KANSAS GAS AND ELECTRIC COMPANY

KMLNRC 84-124
Re: Docket No. STN 50-482
Ref: KMLNRC 84-118 dated 7/20/84 from GLKoester,
KG&E, to HRDenton, NRC
Subj: Technical Specifications

WOLF CREEK GENERATING STATION
UNIT NO. 1

Figure S.1-4
Boundary for Liquid Effluents

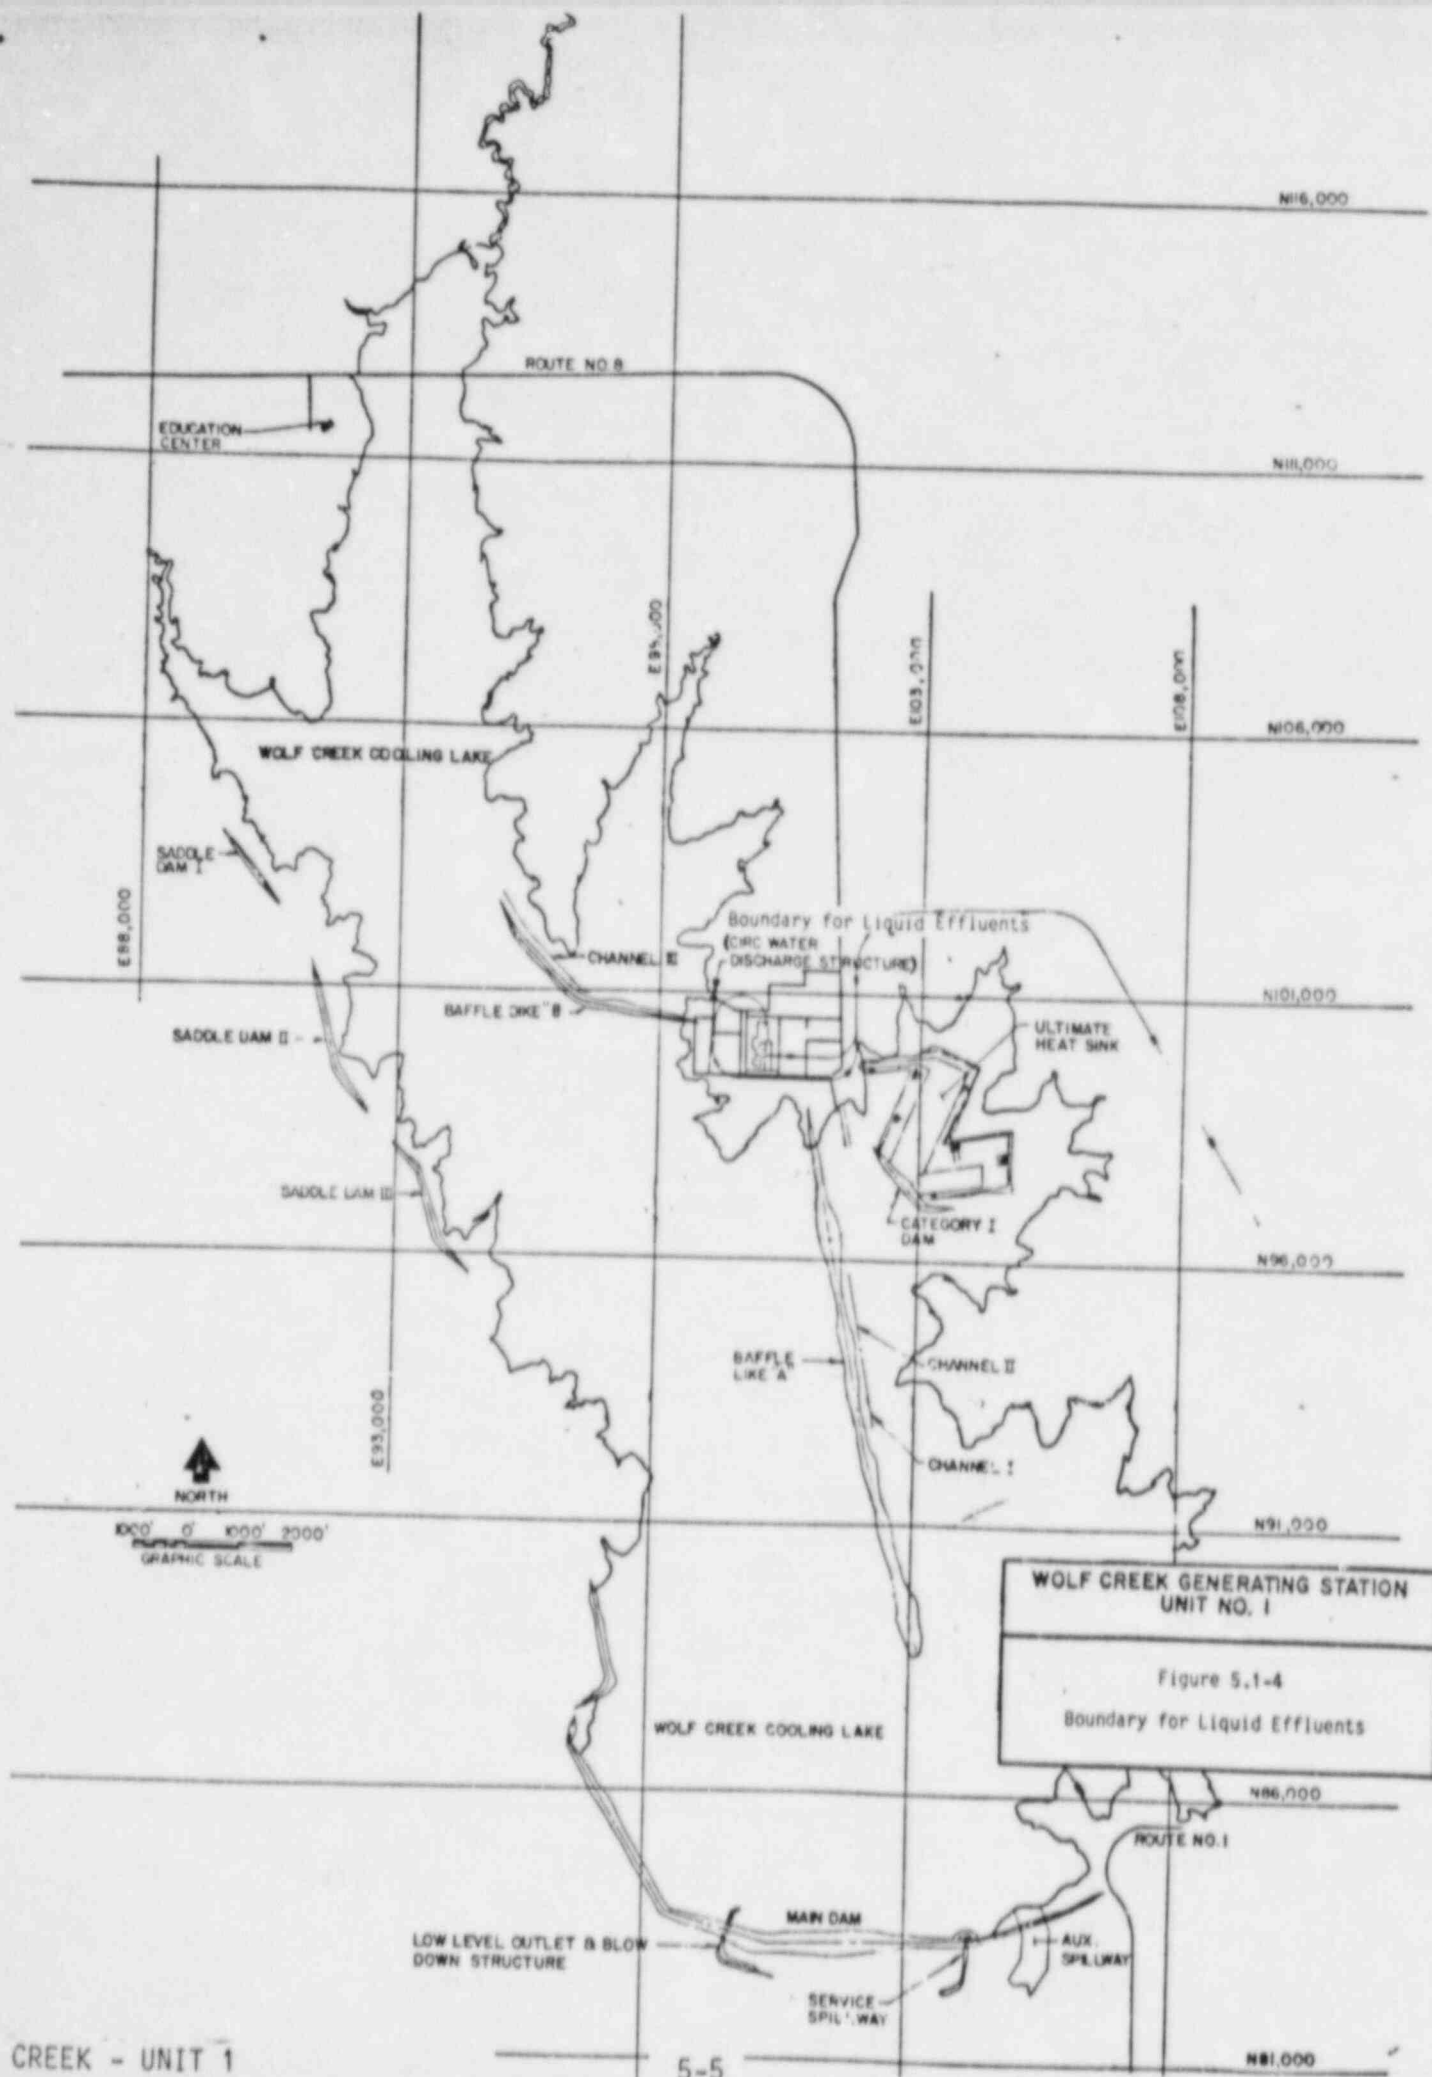
The Referenced letter transmitted the Wolf Creek Technical Specifications "marked up" to indicate changes. Figure 5.1-4, which was transmitted in the Referenced letter, does not correctly reflect the boundary for liquid effluents at Wolf Creek.

Transmitted herewith is a revised Figure 5.1-4 which correctly reflects the boundary for liquid effluents at Wolf Creek. This figure should supersede the previously submitted figure in its entirety.
